UNITED STATES PATENT AND TRADEMARK OFFICE

10/734,678

Office Action Summary	Application No. 10/734,678	Applicant(s) WOMACK ET AL.	
	Examiner Stephen Gordon	Art Unit 3612

DETAILED ACTION

marked up figure for 10/734,678
Attachment to F&M

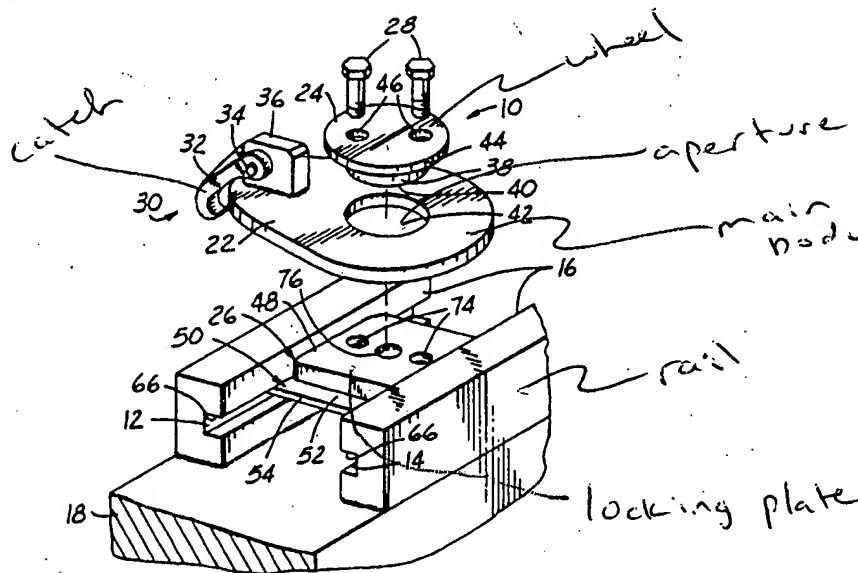
Claim 16, see marked up copy of cover page figure of Nilsson 4,915,342 attached to this action.
